SUBJECT: Virgil C. Summer Nuclear Station
Docket No. 50/395
Operating License No. NPF-12
Relief and Safety Valves
NUREG-0737, II.D.1

Please find attached the South Carolina Electric & Gas Company (SCE&G) response to NRC questions dealing with NUREG 0737, item II.D.1. These question responses have been structured to provide the most concise and applicable answers to the NRC specific requests on the original submittal.

RESPONSES TO SAFETY EVALUATION QUESTIONS
TMI ACTION NUREG-0737 II.D.1
FOR V. C. SUMMER UNIT 1

093 B/MX-ROH-093

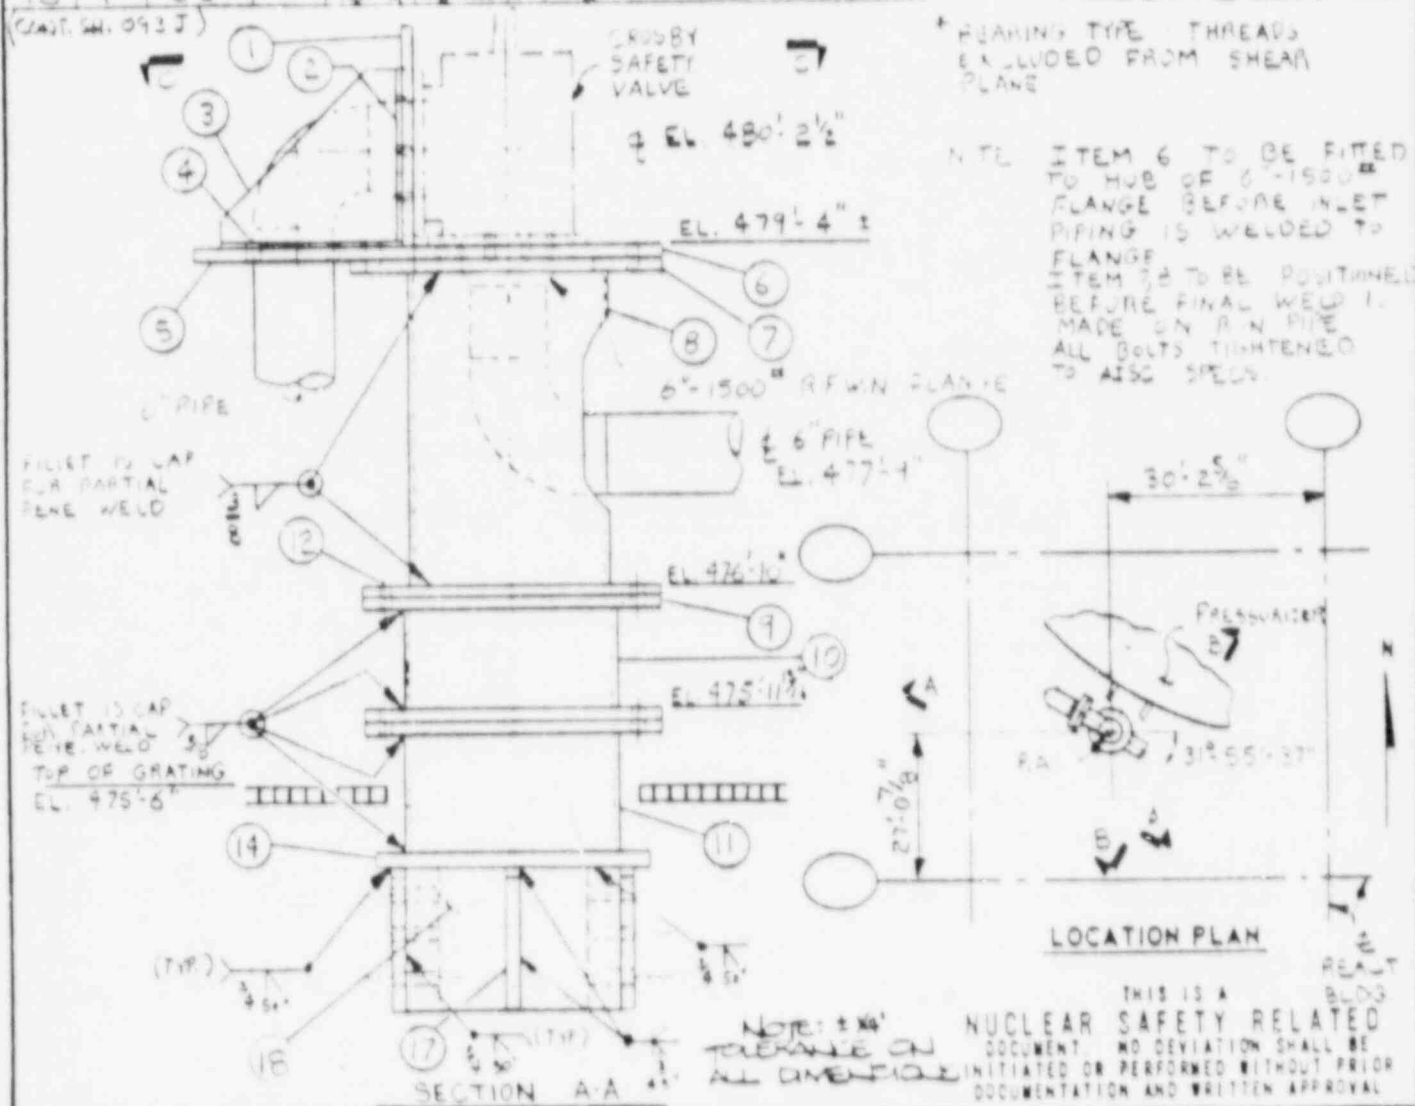
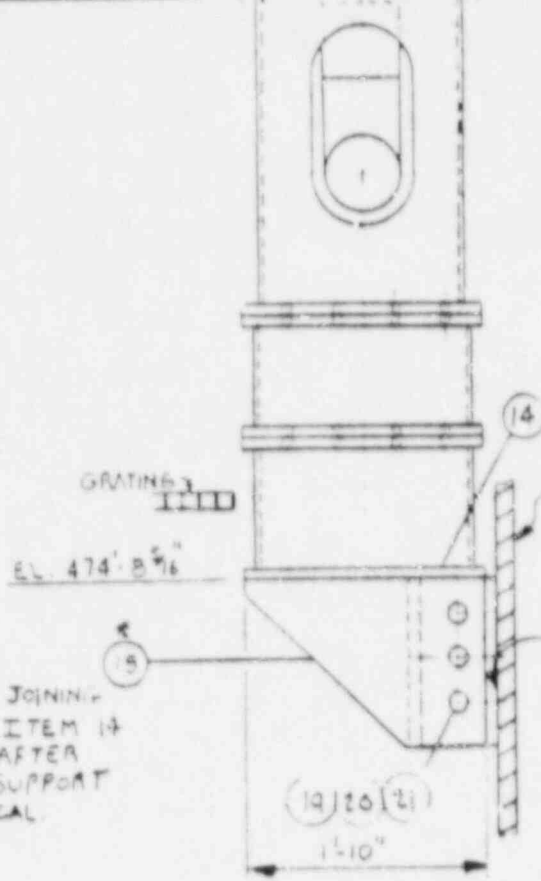
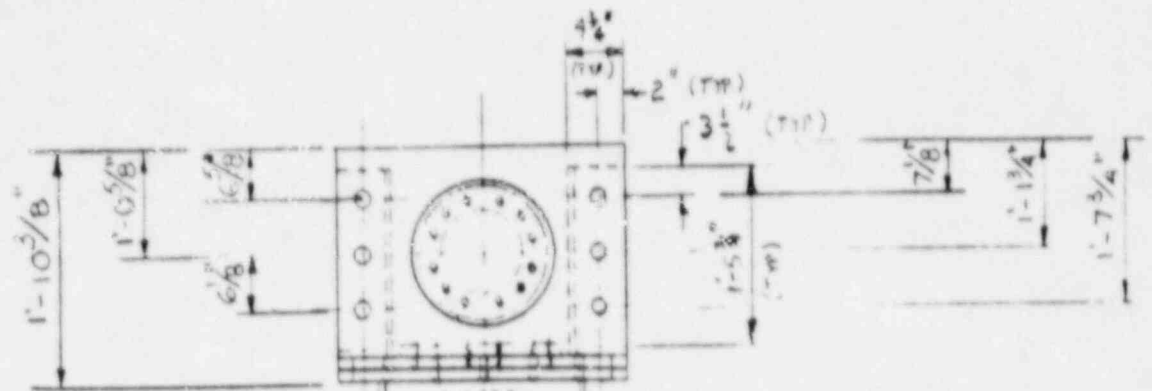
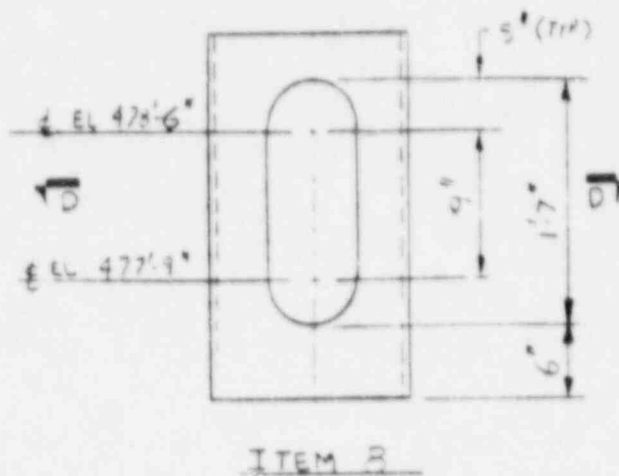
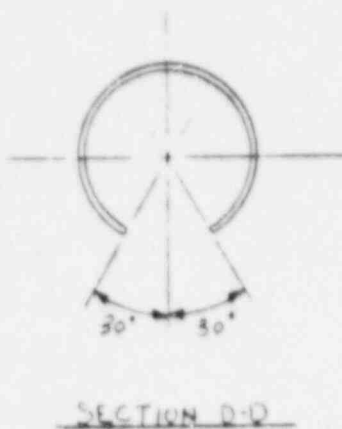
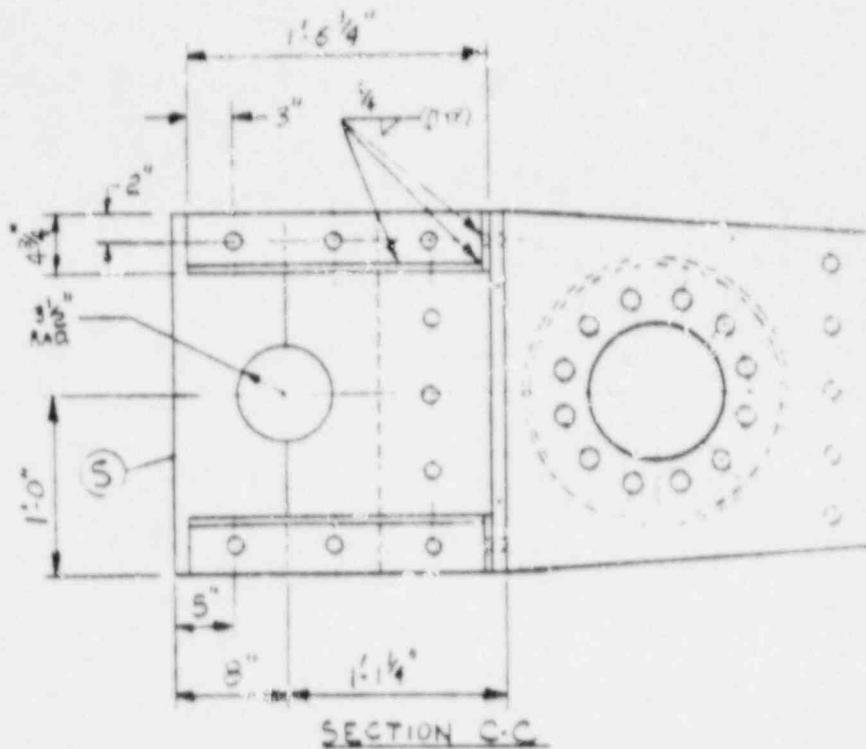
Bending moments are induced on the safety valves and PORV's during the time they are required to operate because of discharge loads and thermal expansion of the pressurizer tank and inlet and outlet piping. Make a comparison between the predicted plant moments with the moments applied to the tested valves to demonstrate that the operability of the valves will not be impaired.

To assist with the reviews, the details of the SRV supports have been included and are on pages 7-16 through 7-23. Please note that the SRV is anchored at its base and guided on the discharge to allow only axial movement. The only EPRI PORV moment was 43,000 in.-lb, which is larger than any allowable moment (page 7-14) to which the valves are qualified.

FIGURE A-1
PIPE FORCE ELEMENTS FOR SINGLE CNT. VOLUMES

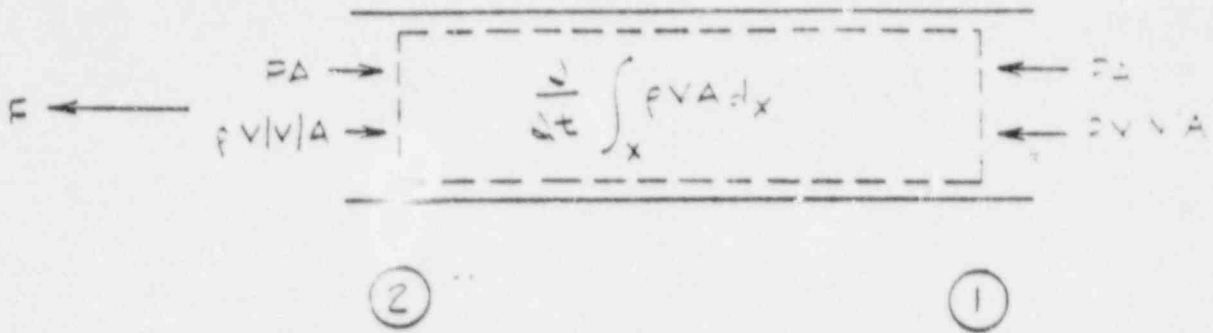
The submittal states that the thermal hydraulic analysis was performed using RELAP 5/MOD1 and that the RELAP 5 control system was used to calculate the fluid forces. Identify the methodology used to calculate forces from RELAP 5/MOD1 and provide additional verification that the methodology produces accurate force histories for similar problems.

as depicted in Figure A-1.
